# VAN'S AIRCRAFT, INC.

## SERVICE BULLETIN SB 12-08-14

**Subject:** AN4 bolt installation, wing attach.

**Affected Models:** RV-7/7A, RV-8/8A and RV-9/9A

**SECTION B-B**

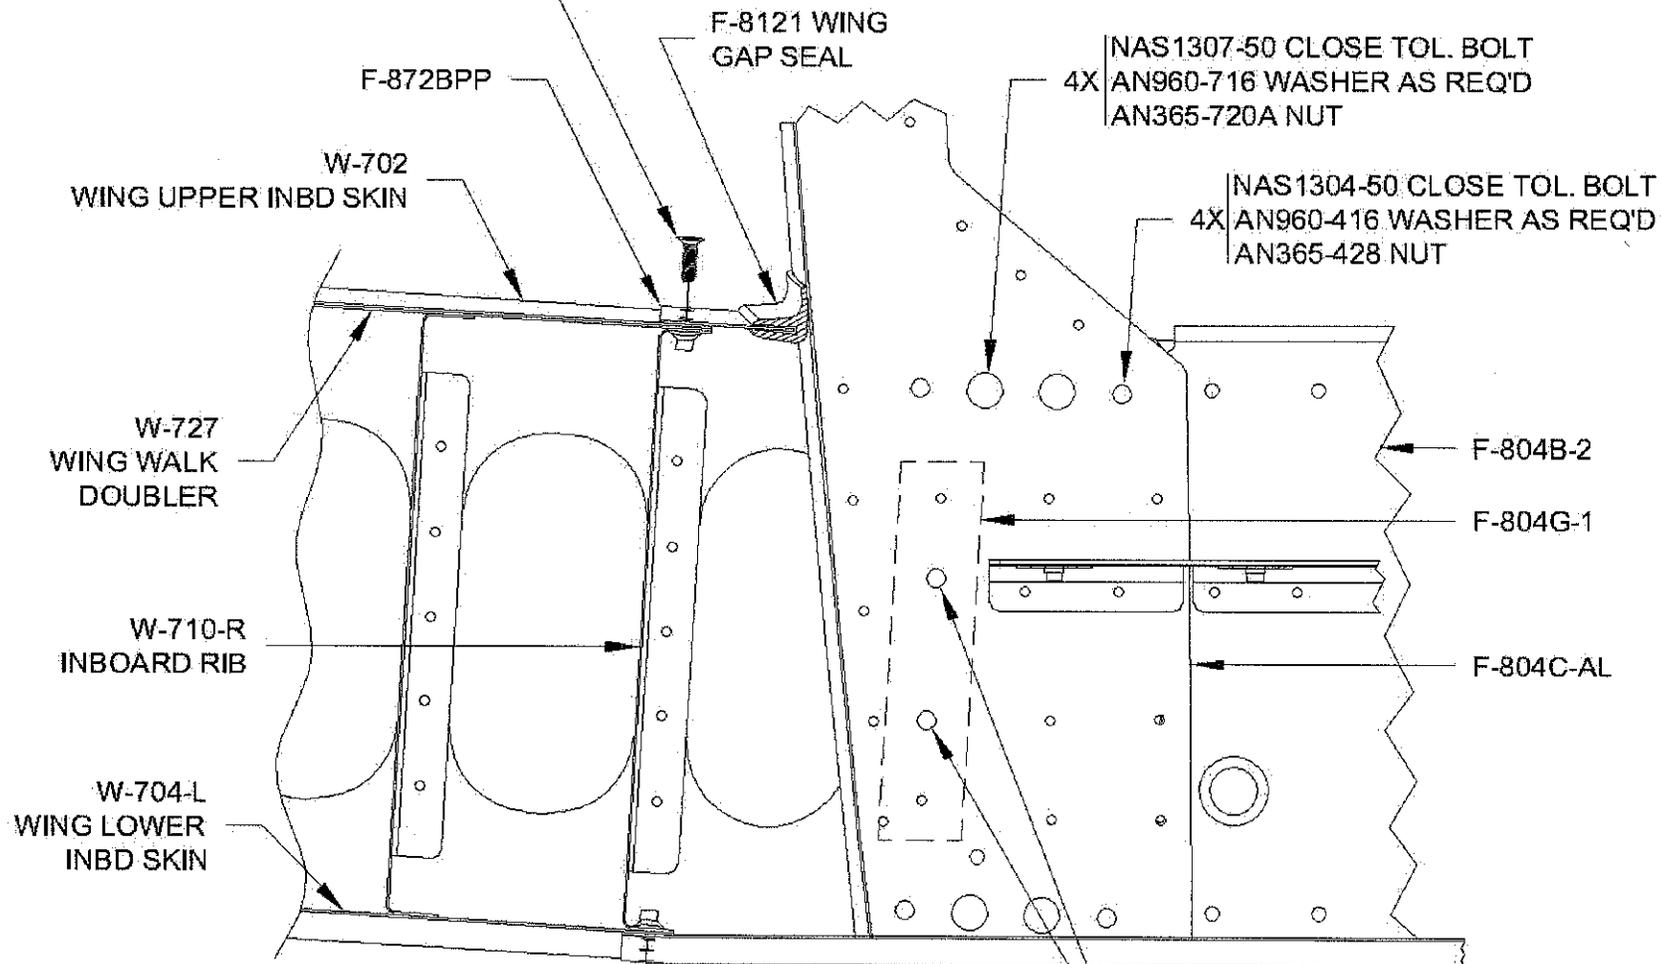
**Synopsis:** Missing AN4-13A bolts securing the F-704G (RV-7/7A), F-804G (RV-8/8A) or F-904G (RV-9/9A) vertical bars. These bolts are to be installed during final wing installation prior to first flight. Inspections on several RVs in the field have revealed that these bolts were never installed during wing installation.

3. Using a flashlight and small inspection mirror, look through the aileron push-rod hole in the side of the fuselage and verify that the four AN4-13A bolts indicated in the appropriate drawing below are installed (two on each side).

A drawing showing the location of the bolts in question is shown on the following page. This example shows the location of the bolts on an RV-8/8A. The bolt locations are very similar on the RV-7/7A and RV-9/9A. Drawing references for each model are listed below.

5. If any of the bolts are missing, install the appropriate hardware and torque the nuts to 50-70 in.lb. (On most models, it will be necessary to remove one or more floor panels to install this hardware.)

AN4-13A BOLT  
AN960-416 WASHER  
(GOES THRU F-804C-AL,  
F-804B-2, F-804G-1, W-706C,  
W-706A-L, AND INTO NUTPLATE)
